**NOTICE OF ADDENDUM
ADDENDUM NO. 1
City of Madison, Engineering Department**

**CONTRACT NO. 9359
Country Grove Park Shelter**

This addendum is issued to modify, explain or correct the original Drawings, Specifications, or Contract Documents marked as **Country Grove Park Shelter, City of Madison, Contract #9359, as issued on February 1, 2024** and is hereby made a part of the contract documents.

1 FOUNDATION PLAN
1/4" = 1'-0"

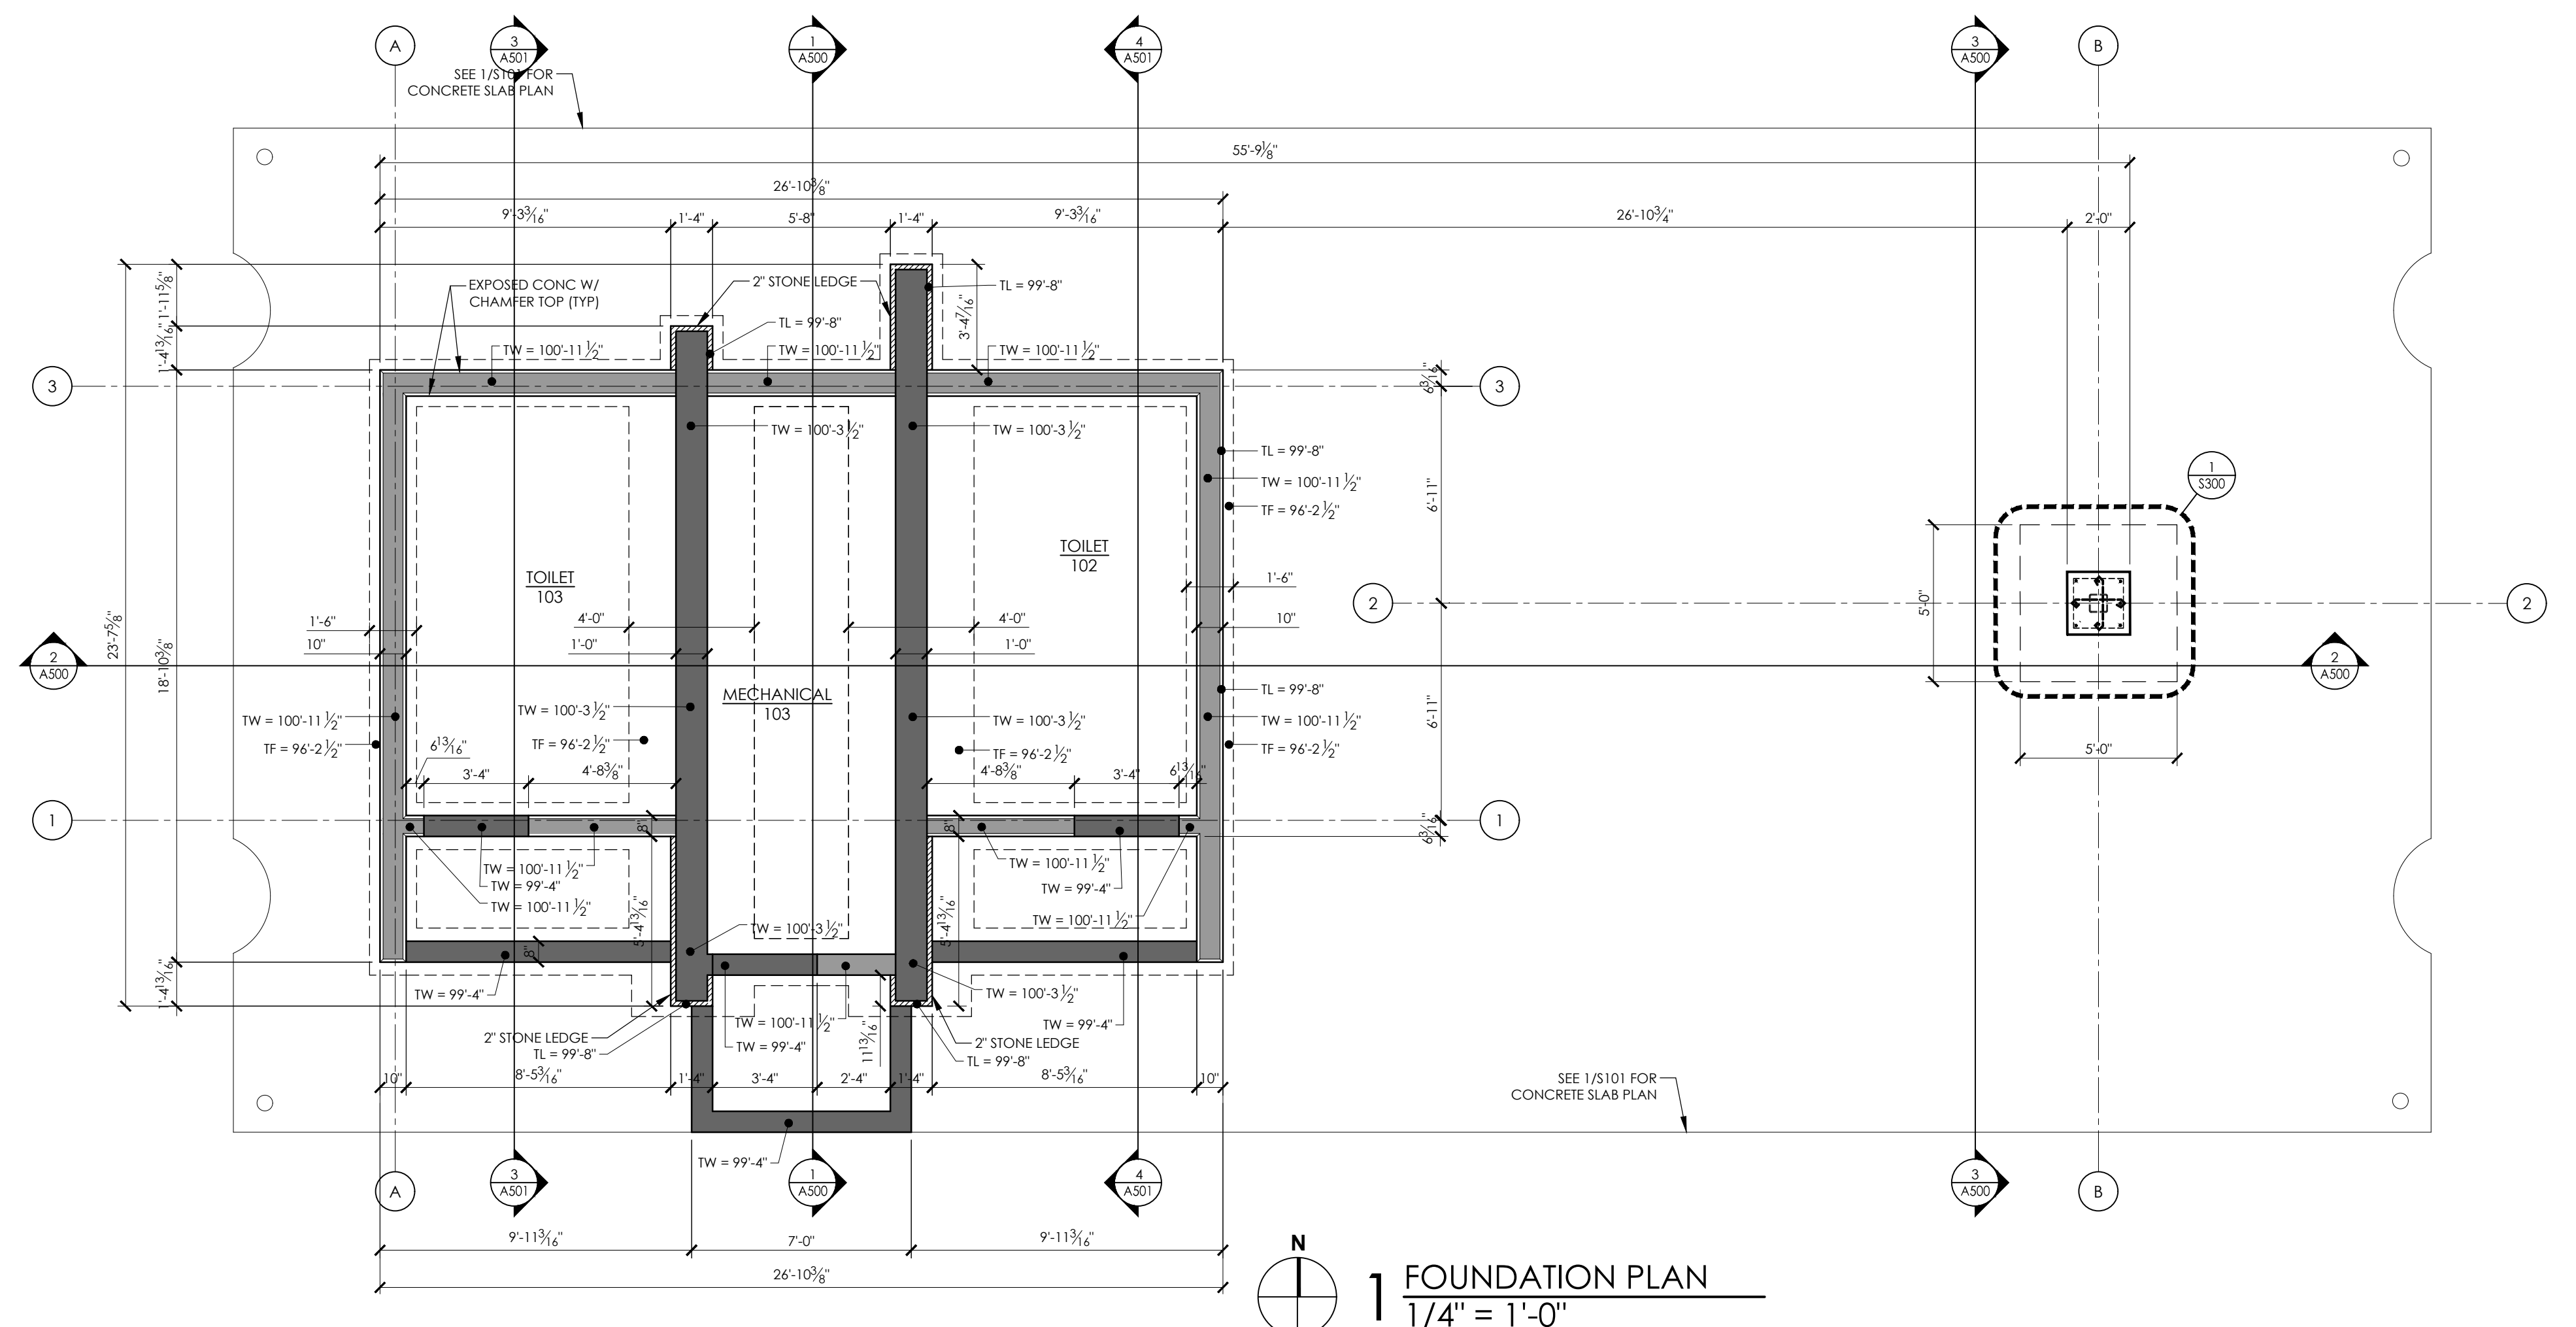
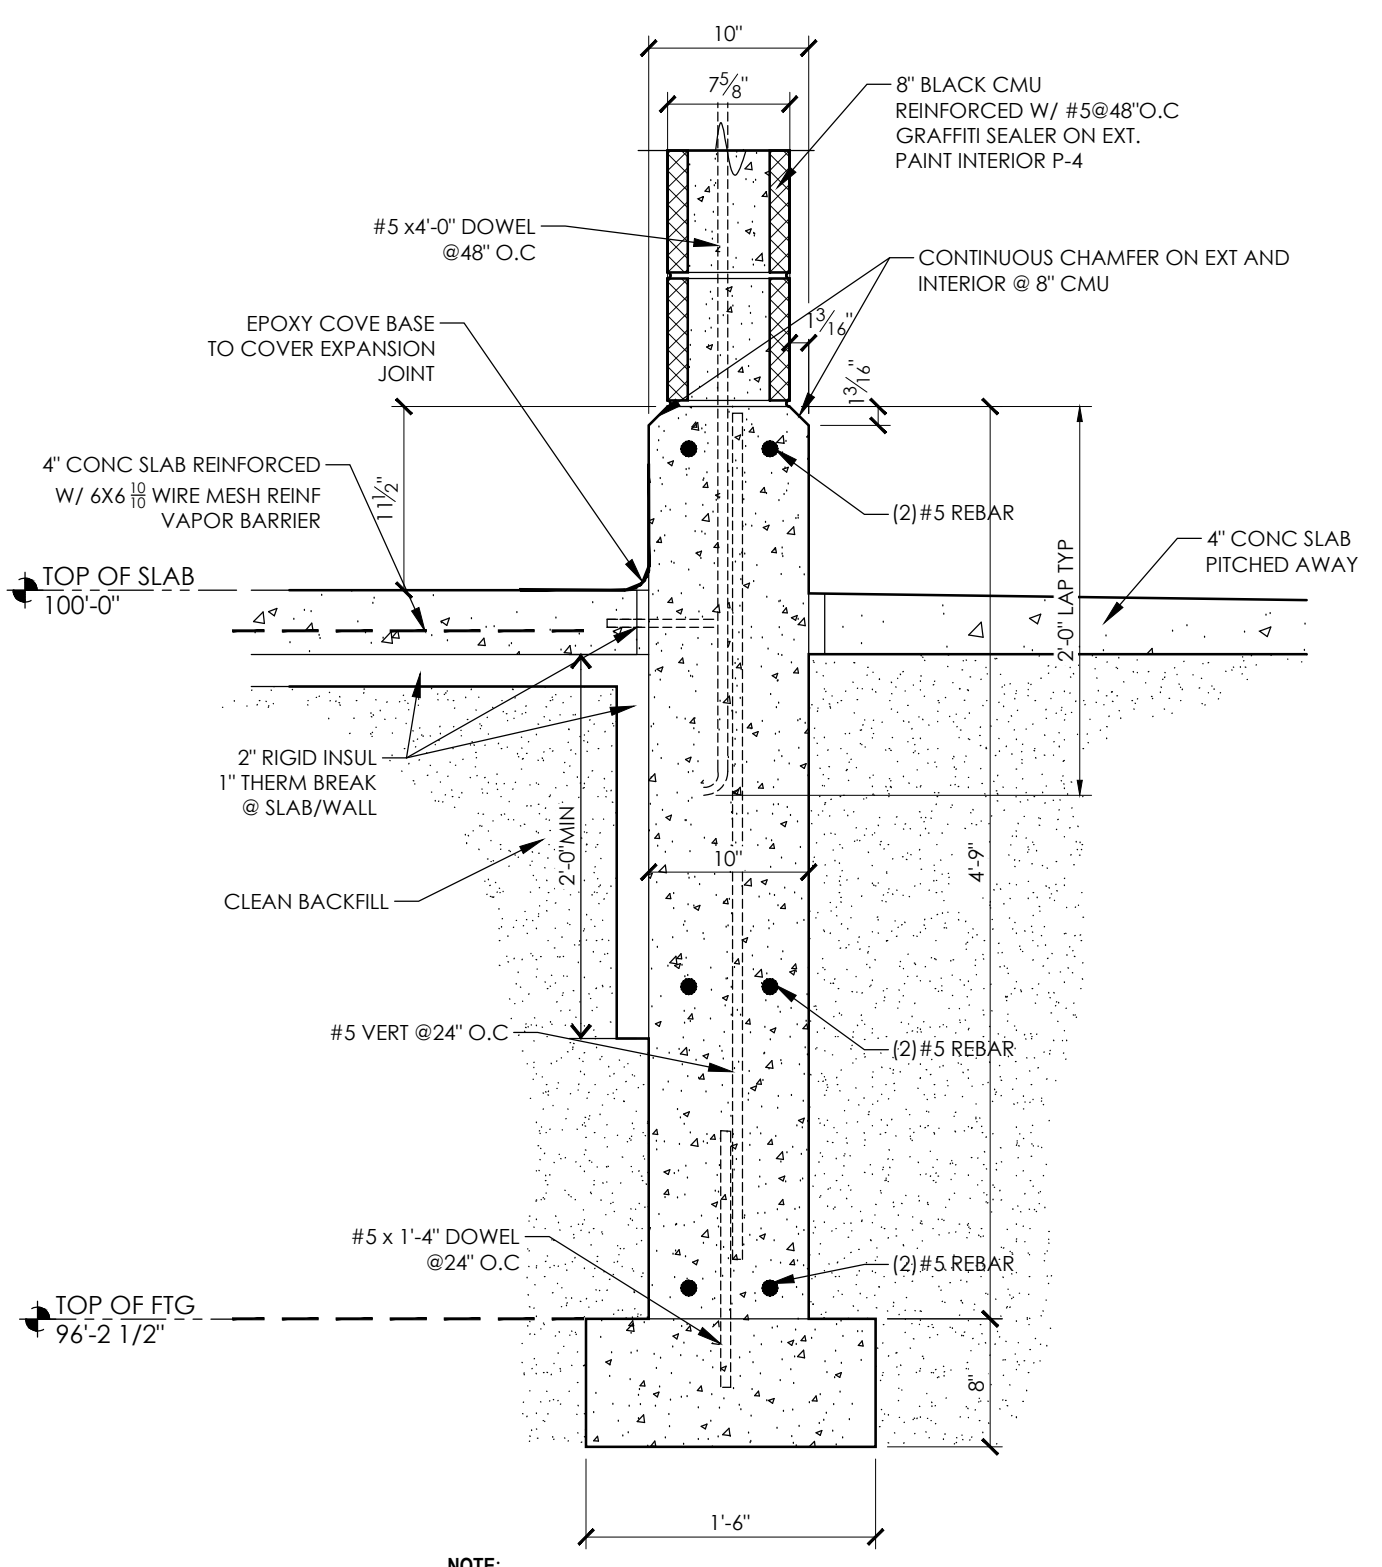
- E. Q5: Structural vs Grading Drawings - Structural drawings indicate a top slab elevation of 100 ft. Grading drawings indicate a top slab elevation of 976. Please clarify.

- Drawing S100:** Replace with attached sheet.
 - Revise Building elevation “976.00” to read “Fin. Floor Elevation 976.00”.

A5: Fin. Floor Elevation 976.00' = 100'-0" see attached drawing C1.5 & S100
